Re: The 1130 Mission Project Appeal

Date: 5.10.2024

Please find below a recap of the 1130 Mission project changes since the project was approved by the Planning Commission on January 18th, 2024. The changes are captured in a combination of New Conditions of Approval and updated project drawings. All of the changes are in response to the appeals and additional requests from the neighbors.

Planning Package Rev3 - Base density diagram w/ revised unit sizes (NTS)

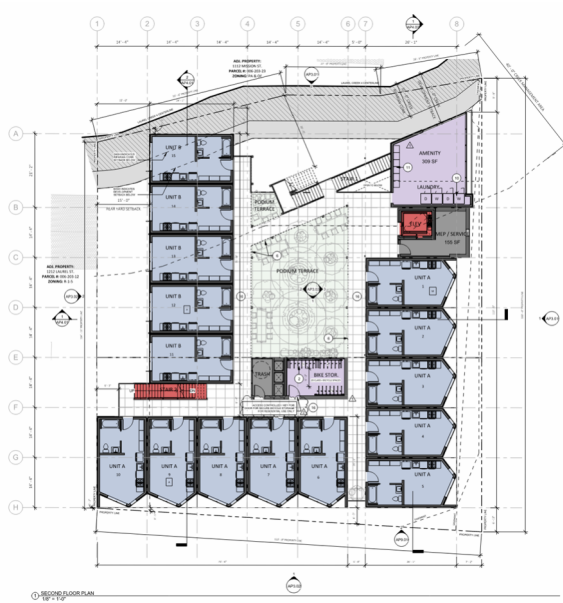
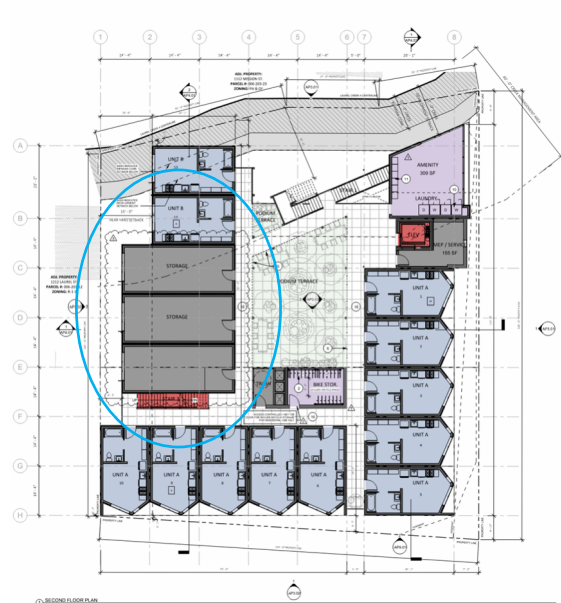
- i. **Base Density Diagram and ADUs:** In response to this we revised our base density diagram from 40 units to 32 units and proposed using 12 conversion ADUs to make up for the base density reduction. A project is allowed 25% conversion ADUs and the resulting ADUs don’t have to adhere to the SRO code. We have proposed them as 1 bedroom units instead of studios. These changes were done to help the financial viability of the project, by creating some larger units and reducing the project’s impact fees. The change from SRO units to conversion ADUs also modified the project’s affordable housing requirement from 8 very low income (VLI) units to 6 VLI SROs and 2 low income (LI) one-bedroom ADU conversions. The Owner has agreed to provide the 2 one-bedroom ADUs at VLI. Assuming a 5% cap rate, the deeper

- ii. **Unit Size:** When we began the project we were calculating the unit size as the gross residential square footage in the base project compared to the gross residential square footage in the proposed project. We have since clarified that interpretation of the law and have provided unit size comparisons based on individual units rather than gross residential square footage.
- iii. **FAR:** The original FAR was in compliance, just not shown on the drawings. The updated drawings show the FAR calculations.

Planning Package Rev 4 - Base density diagram 3rd Floor Change which adds 1 unit and gives the project a total of 33 Units (NTS)

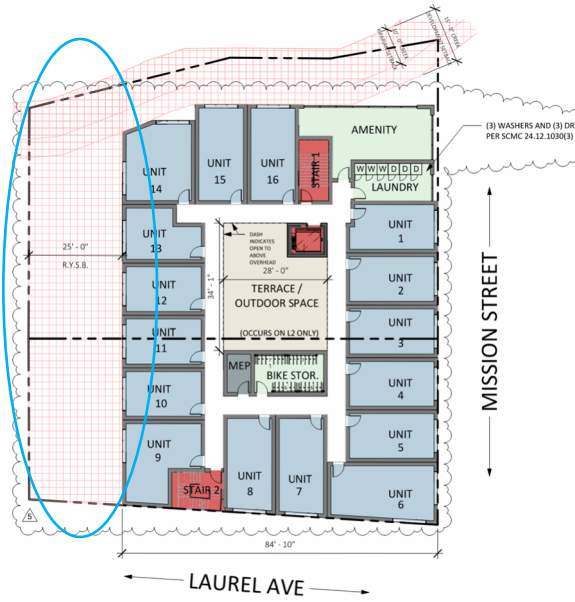
- i. Changed the base density diagram to 33 units which is “less than” a 20% change from 40 base density units. We also reduced our “conversion” ADUs to 11 for planning purposes.

- ii. Updated the base density area, average unit areas and FARs to correspond with the 33 unit change.
 - iii. The neighbors also noted that if our base + bonus units were 47, that would be a 12 unit reduction from 59 total units, which is 20.3%, but the 20% change rule applies to “... number of residential units or square footage of construction ... exclusive of any increase resulting from the receipt of a density bonus ...” so only the change from 40 units base density to 33 units base density is subject to the 20% limit.

Planning Package Rev 5 – Updated base density diagram increasing RYSB from 15' to 35' at upper floors (NTS)

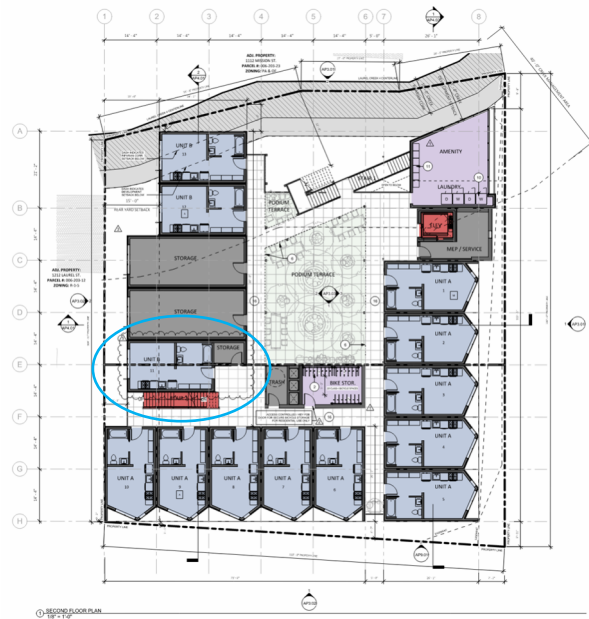
- i. **Setback:** Our interpretation of Density Bonus law at time of original submittal is that because there was a discrepancy in the required setback/stepback between the base CC zoning and Mission Street Overlay, we should use the less restrictive standard that results in the greatest number of units. When this was challenged by the neighbors we did a new density diagram showing the larger Mission Street Overlay setback/stepbacks. The larger setback made no difference to the end result of 33 units of base density, and rather than get into a long and potentially unfruitful conversation about Density Bonus law interpretation, we updated the plans.

- ii. **FAR:** The Appellant’s FAR calculations incorrectly calculate FAR by including parking dedicated to the commercial use and open space.
 - iii. **4.15.24 Submittal 20% Change:** We did miscalculate the number of conversion ADUs that we should have utilized when we redid the base density diagram in Rev #3. We should have used 11 ADU conversion units instead of 12. ($12/59 = 20.3\%$ therefore we were over the 20% change limitation required by SB330). To fix this we changed one of the storage spaces back into a unit. The end result is still 59 units.
